POLICY REPORT

TO: Vancouver City Council
FROM: General Manager of Planning, Urban Design and Sustainability
SUBJECT: CD-1 Rezoning: 6161 Cambie Street (Alliance Francaise)

Landscape Plan

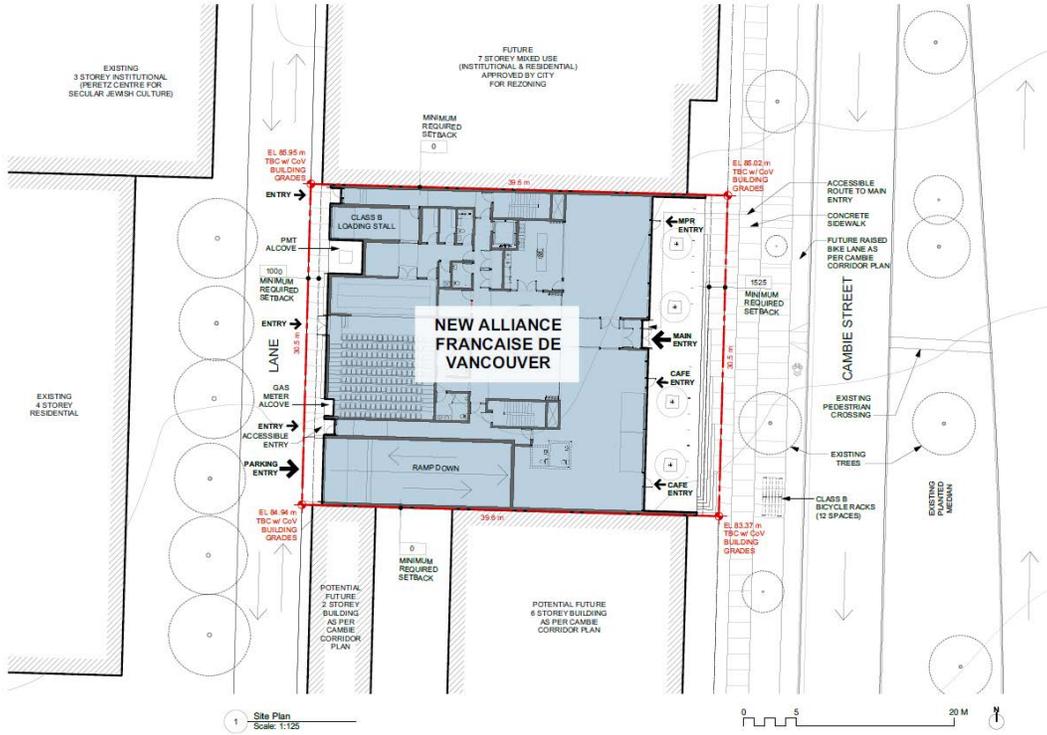
- 6. Design development to confirm the viability for the planting of the four forecourt trees along Cambie Street.

- 7. Design development to increase the width of the linear planter on Level 2, to provide a better balance between hard and soft landscape, and to provide more soil volumes for the tree planting.

26. Delete proposed hardscape in the front boulevard and maintain the existing grass.
27. Delete the proposed new curb and gutter and bike lane, and curb ramp adjacent to the site from the site plan and landscape plan.
